What changes must be made in the program when switching from a 218IF-01 (JAPMC-CM2300-E) card to a 218IF-02 (JAPMC-CM2302-E) card on the MP2000 series controller platform?

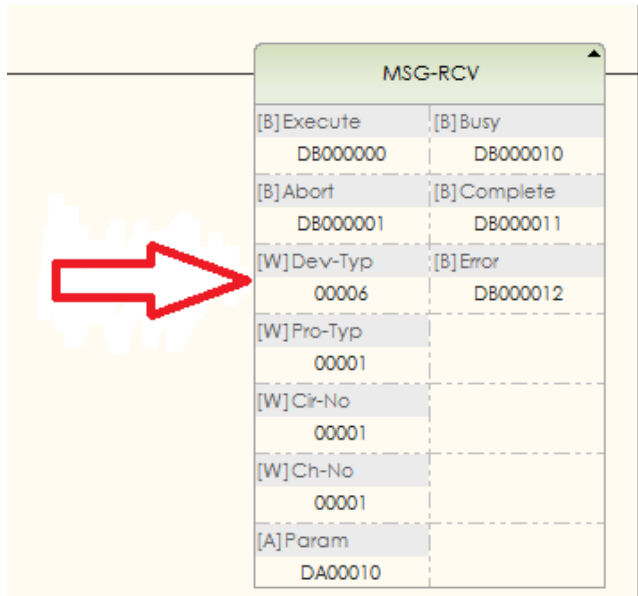
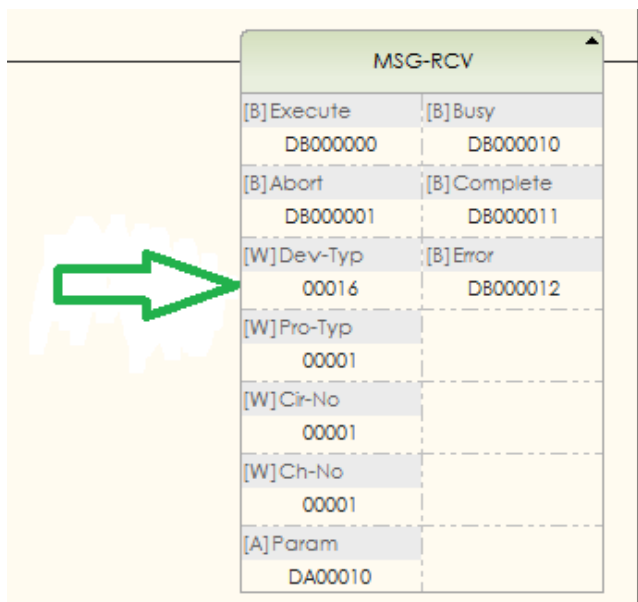
When upgrading the Ethernet card 218IF-01 to a 218IF-02 you must change the Device Type in the MSG-RCV or MSG-SND function block.

This is the setting for 218IF-01 (JAPMC-CM2300-E): Device Type = 6

This is the setting for 218IF-02 (JAPMC-CM2302-E): Device Type = 16
